Our Ref: 18RCP03B.2
NSW RFS Ref: DA20210202000372-Original-1

**Re: Bushfire Review
243 Forrester Road, St Marys**

Figure 1 – Bushfire Protection Measures
(source: TBE, 2020)

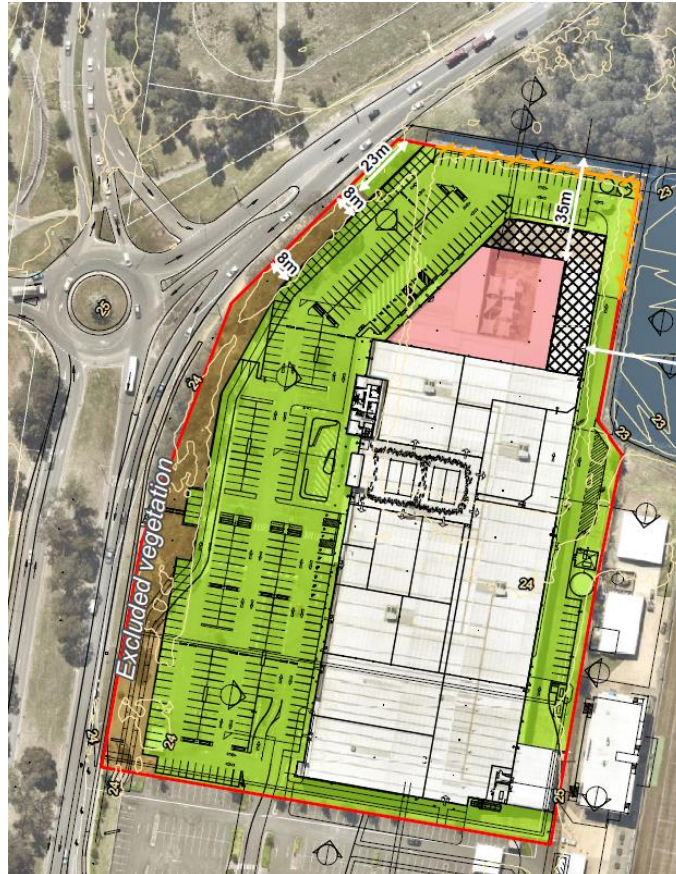
This condition requires the entire site to be maintained as an Inner Protection Area. This would therefore include the area identified as 'excluded vegetation' within the figure below. Updated landscape plans will be required to cover this area to ensure compliance with this condition.

Travers bushfire & ecology can confirm that the proposal is capable of complying with this condition. However the landscape plan is to be updated to include the entire site (to include the 'excluded vegetation' area as identified in Figure 1).
